**The Flight of
American Airlines 587
November 12, 2001**

**SUBMISSION OF THE
ALLIED PILOTS ASSOCIATION
TO THE NATIONAL TRANSPORTATION
SAFETY BOARD**

**REGARDING THE ACCIDENT OF
AMERICAN AIRLINES FLIGHT 587
AT BELLE HARBOR, NEW YORK
NOVEMBER 12, 2001**

NTSB DCA02MA001

Figure 3.1 Depicted Flight Path of AA 587 and JAL 47

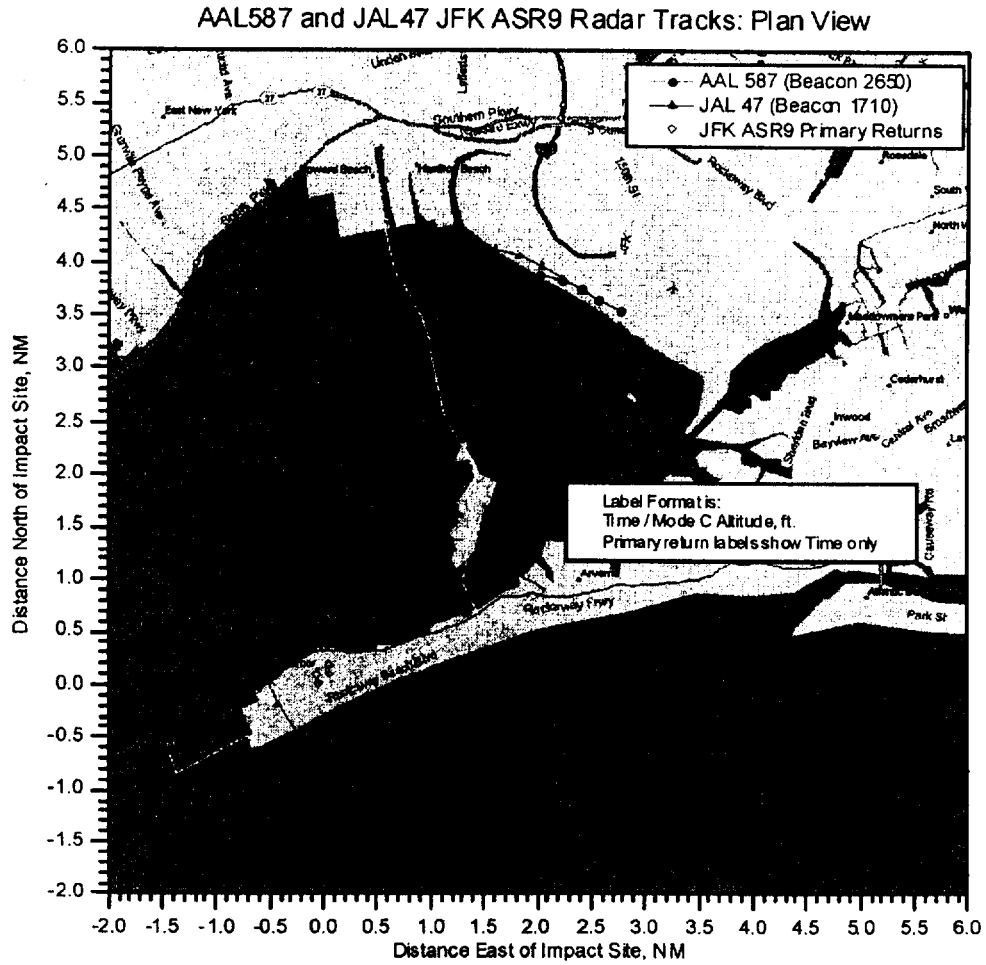
AA 587 took off from Runway 31L with the required two minutes of separation from JAL 47. Upon departing, the Air Route Traffic Control Center (ARTCC) gave the accident aircraft a turn to the WAVEY intersection. This vector placed the American airplane inside the turn of the preceding 747, effectively creating a rendezvous turn. The flight path of the two airplanes is depicted in Figure 3.1 (Official Docket Aircraft Performance Report 47). The turn immediately reduced the separation between the two aircraft, exposing AA 587 to a more powerful wake vortex than the departure separation should have assured. Additionally, the prevailing winds blew the vortices from the 747 into the flight path of the A300. Both of these hazards occurred without the knowledge of the 587 flight crew, inadvertently exposing them to dramatically-increased risk.

The NTSB should recommend that the FAA reexamine the validity of current ATC wake turbulence separation standards. Focus of the review should be on the standards for the wide range of “heavy” airplanes currently in operation, and for larger aircraft, such as the Airbus A380 coming in the near future. This examination should include new technology and should study proposals for improving controller training and understanding of wake vortices, including variables such as relative wind, atmospheric stability, and ATC vectoring.
